RE: J. Leon Rutt  
Plan Review No. 2  
RETTEW Project No. 119162000

On behalf of our Client, we are hereby submitting the revised plans, and supporting documentation for the above referenced project. The plans have been revised per the Lancaster Civil Engineering Company's comments dated October 19, 2023. Our item-by-item response to each comment appears in **bold**.

RE: Preliminary/Final Land Development Plan  
For Leon Rutt  
Waiver, Deferrals and Modifications  
RETTEW Project No. 119162000

**STORM MANHOLE**

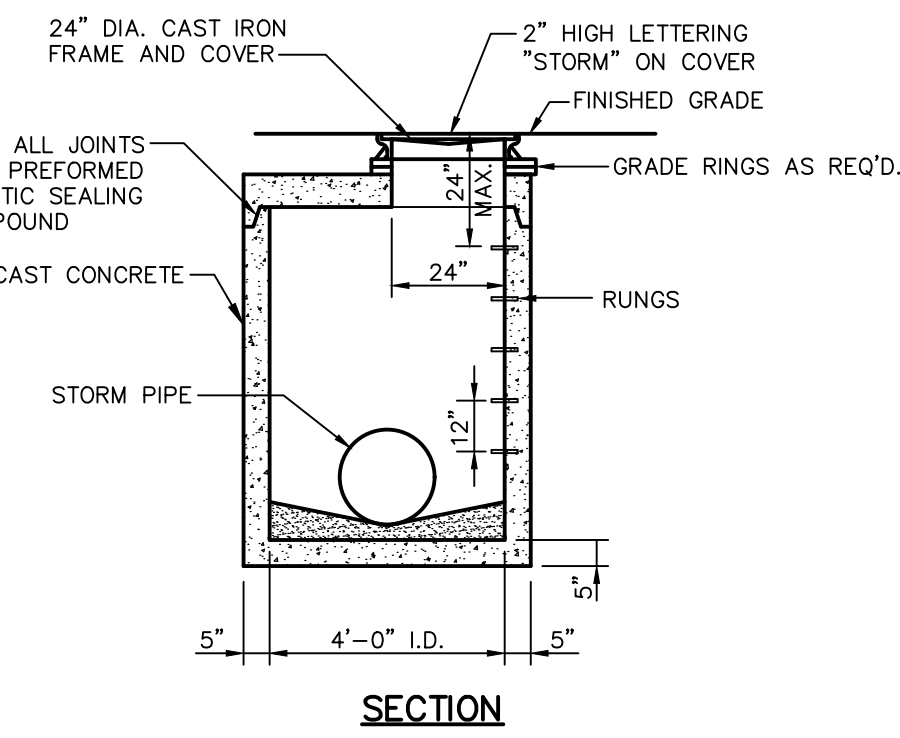
**Response: The grade was revised to obtain 1 foot of cover, refer to sheet 8.**
51. The height of the manhole shown in the Storm Manhole construction detail does not vary (113-37.C(1)(c)).

**Response: The detail was revised, refer to sheet 11.**
52. Manholes shall be made of concrete (113-37.C(1)(c)[1]). The Storm Manhole detail shall specify this requirement.

**Response: The detail was revised to depict the concrete, refer to sheet 11.**
53. Backfill requirements shall be provided for pipes installed in vegetated areas (113-37.C(3)(a)). The backfill requirements for vegetated areas shall specify that the backfill be suitable on-site material that is free of objectionable and detritus material.

**ANTI-SEEP COLLAR**

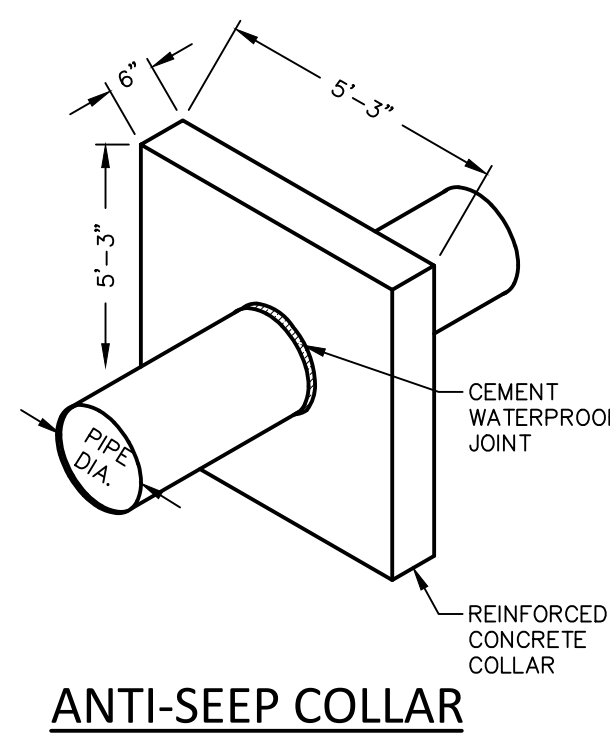
- d. Anti-seep collars are required.  
**Response: An Anti-seep collar has been provided. Please see the plans for the location and details, refer to sheet 11.**

**TRASH SCREEN (OS-1)**

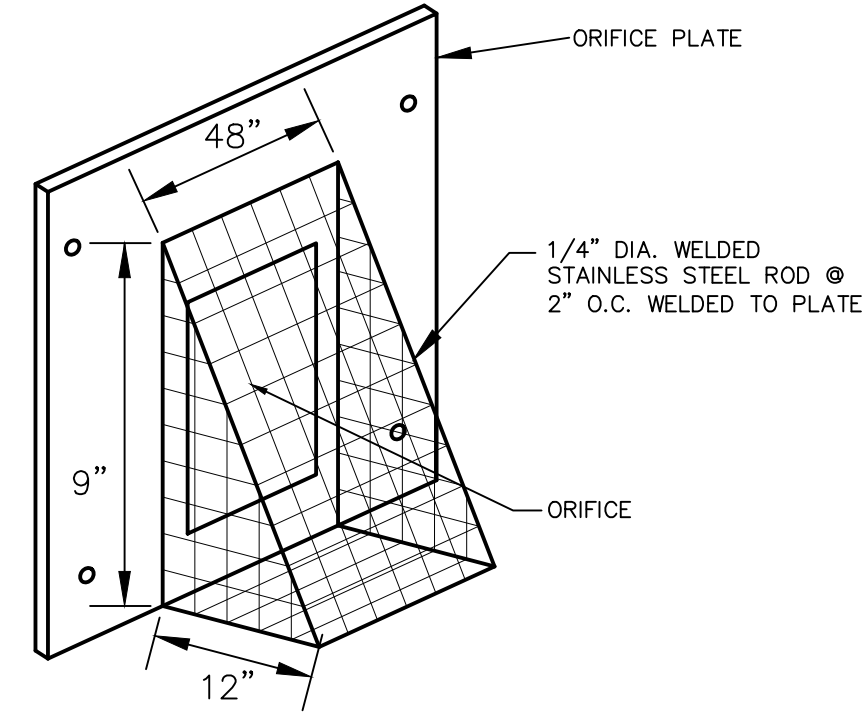
**Response: The detail was revised to specify class 1 backfill, refer to sheet 11.**
55. A protective barrier device shall be provided for the 18" pipe terminating at the stormwater basin (113-37.C(9)(a)).

**Response: A trash screen is called out on sheets 5 and 11.**
56. The landowner shall execute the final documents prior to final plan approval (113-41.B).
